RICHMOND COMMUNITY SCHOOL
Richmond High School: Mechanical Modernization Project
LWC Commission No. 20104.02

ADDENDUM #03
October 3, 2021

B CONDUIT WALL SLEEVE INSTALLATION
SCALE: NONE

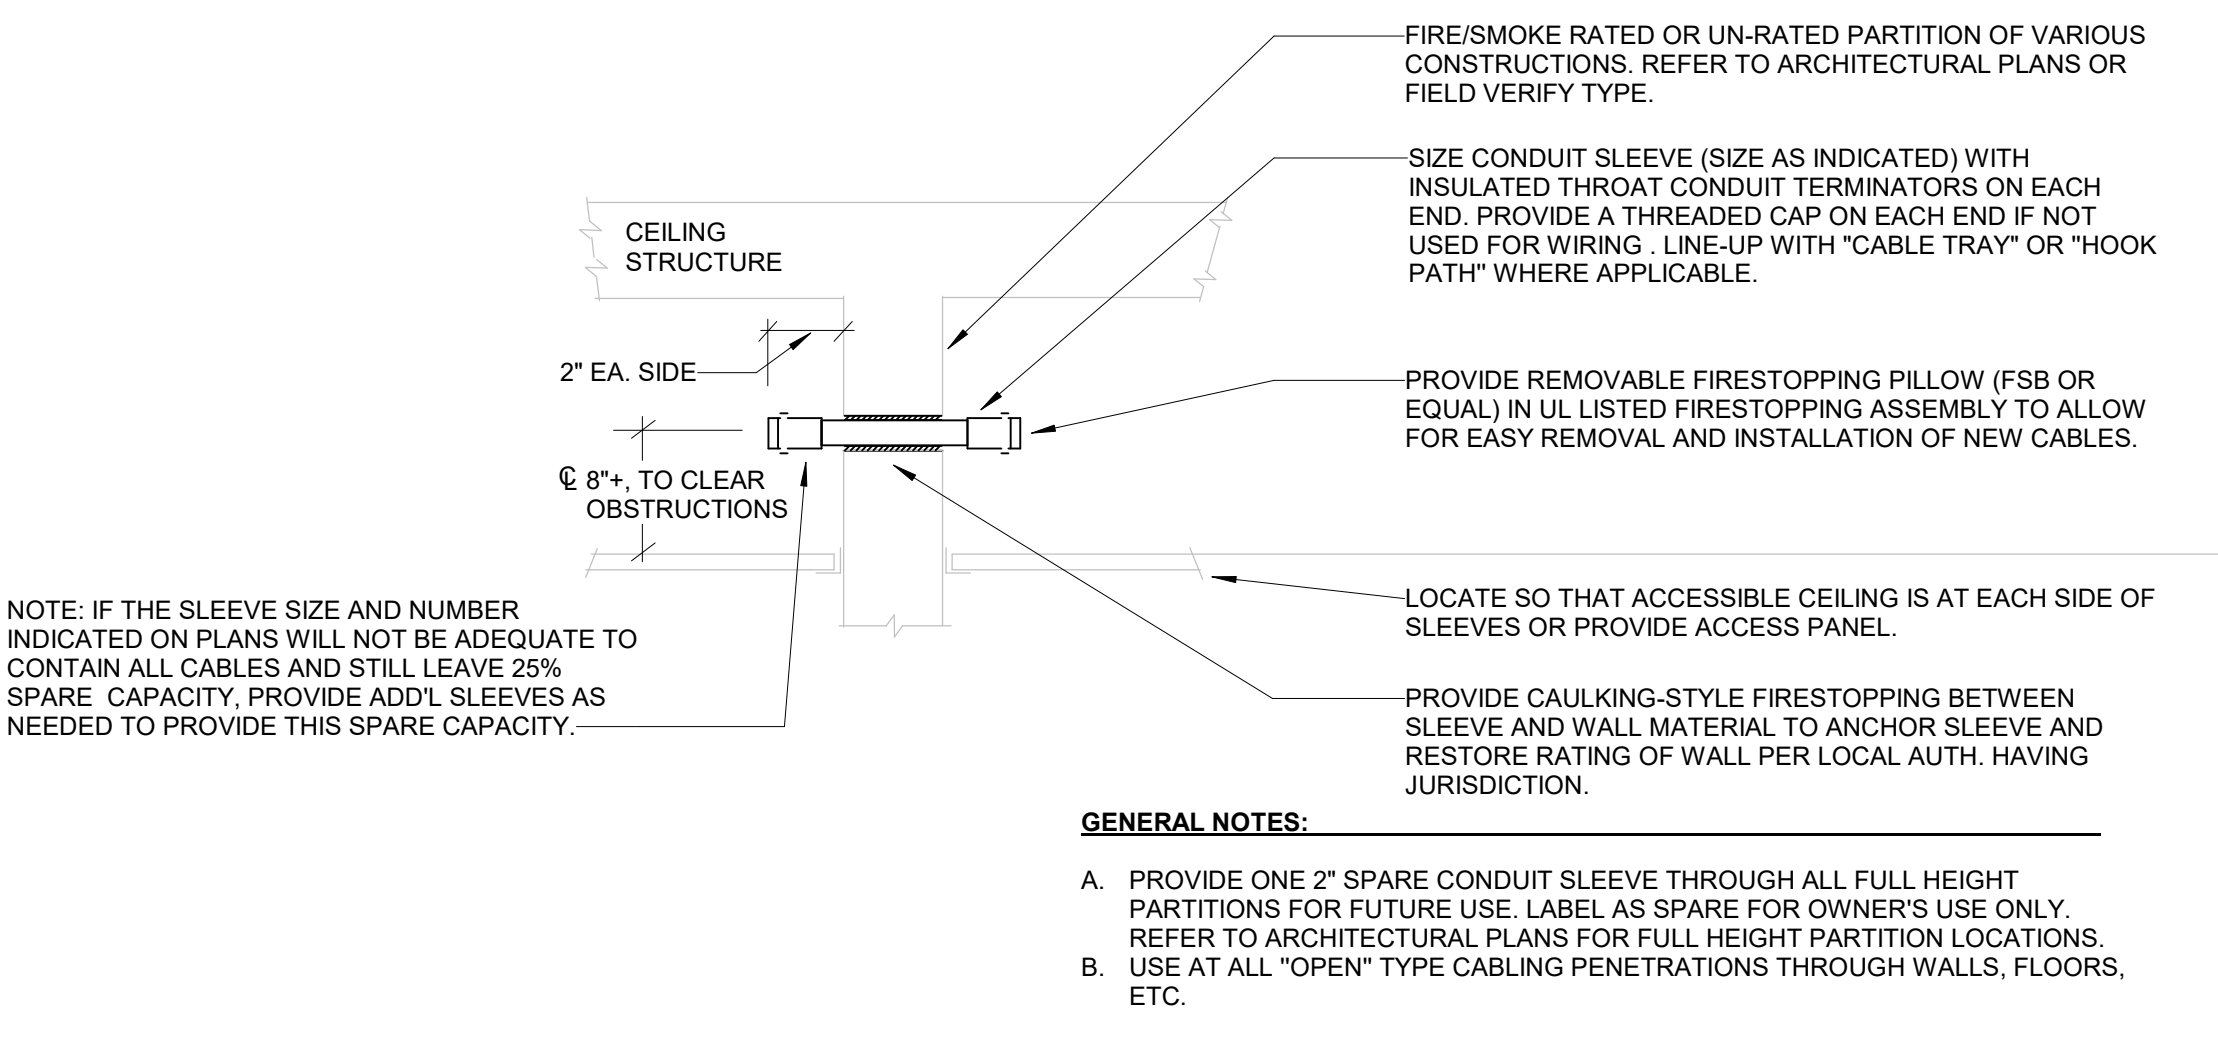
ITEM NO.7 Drawing E002

- A. Added fixture type T3 to fixture schedule.

Comm. No.	Date
	20104.02	08.27.2021
	Drawn	Drawing No.
	NGM	E103
Checked	JAE

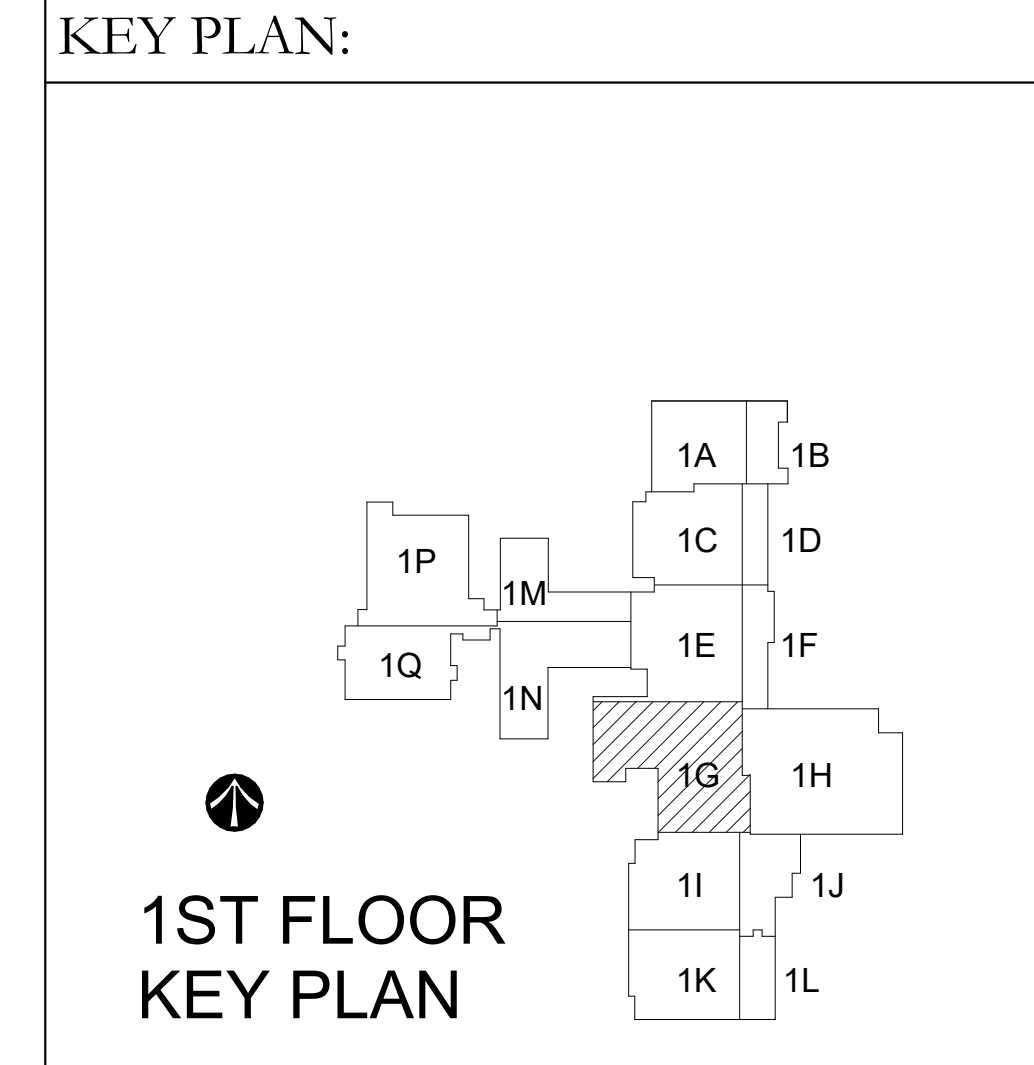
ITEM NO.8 Drawing E103

- A. Added demolition of existing lighting and lighting controls in natatorium offices T173A and T176A.

Comm. No.	Date
	20104.02	08.27.2021
	Drawn	Drawing No.
NGM	E103A	
Checked	JAE

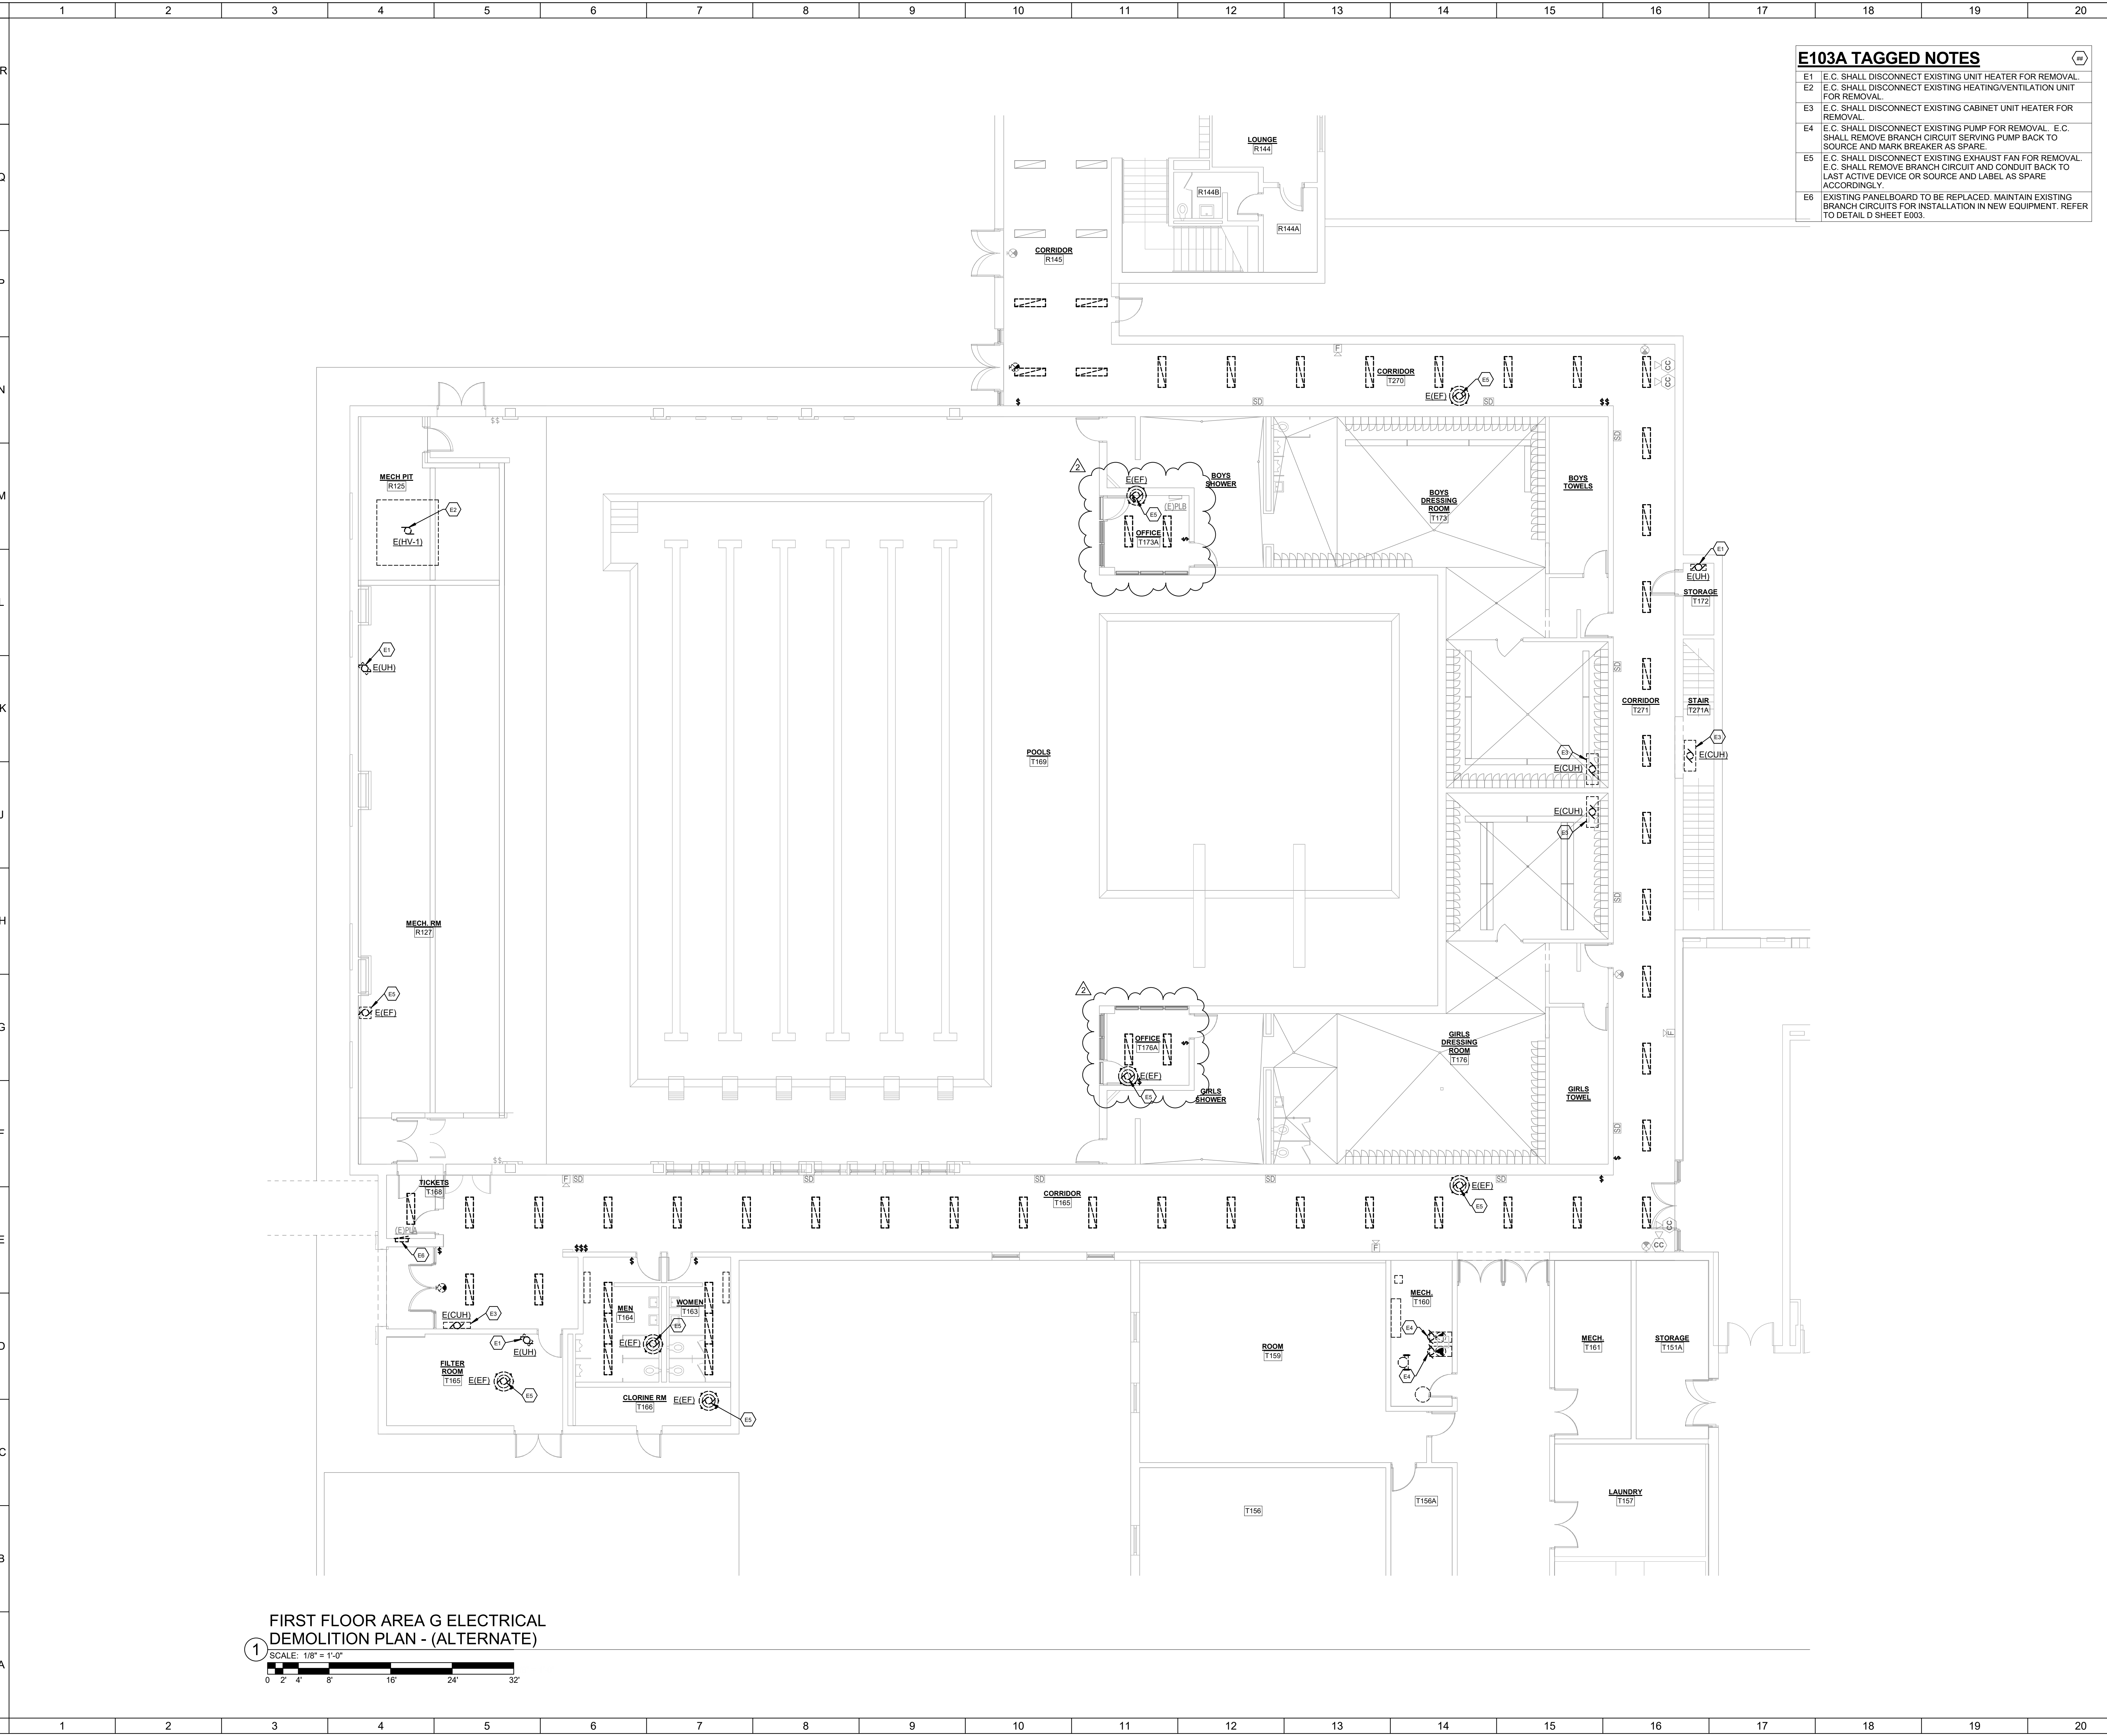
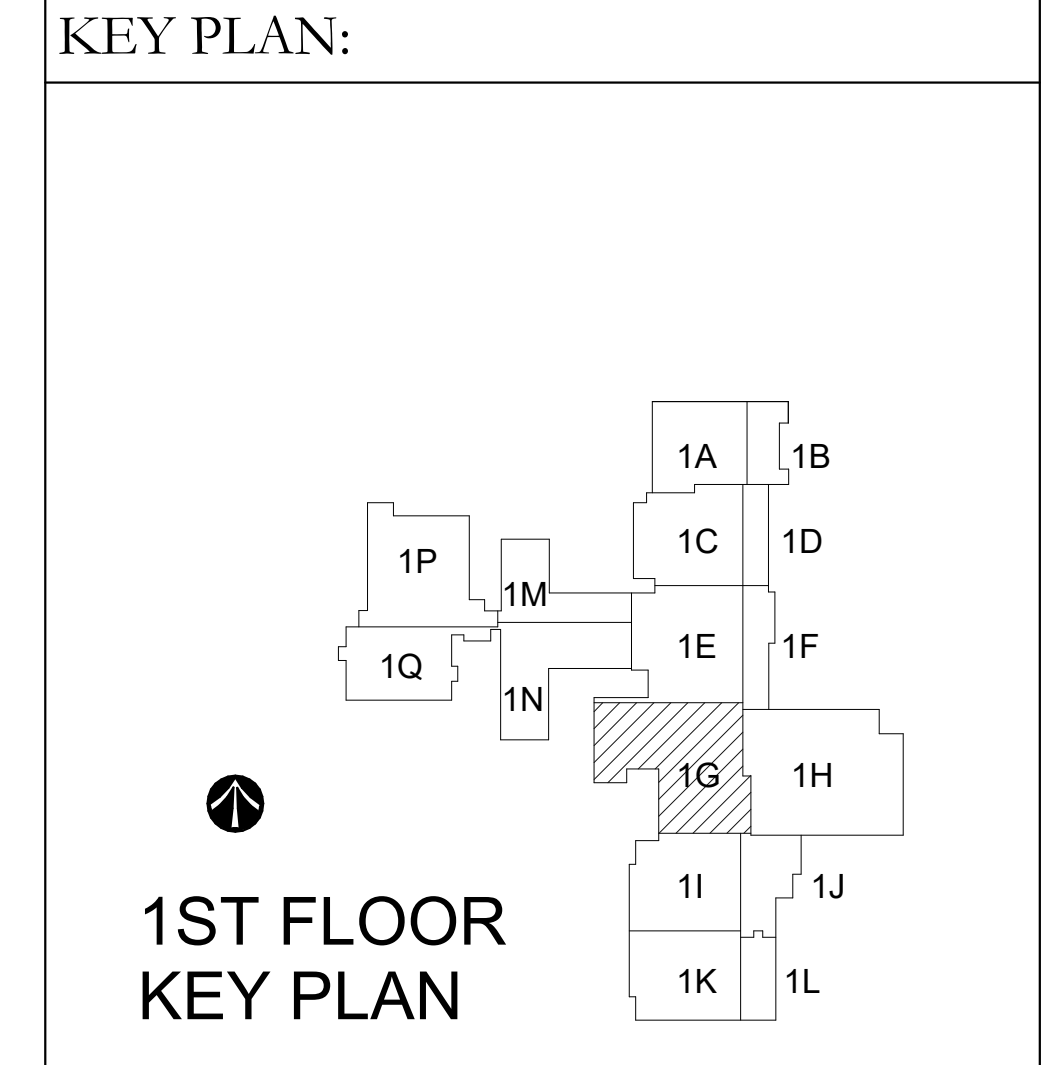
ITEM NO.9 Drawing E103A

- A. Added demolition of existing lighting and lighting controls in natatorium offices T173A and T176A.
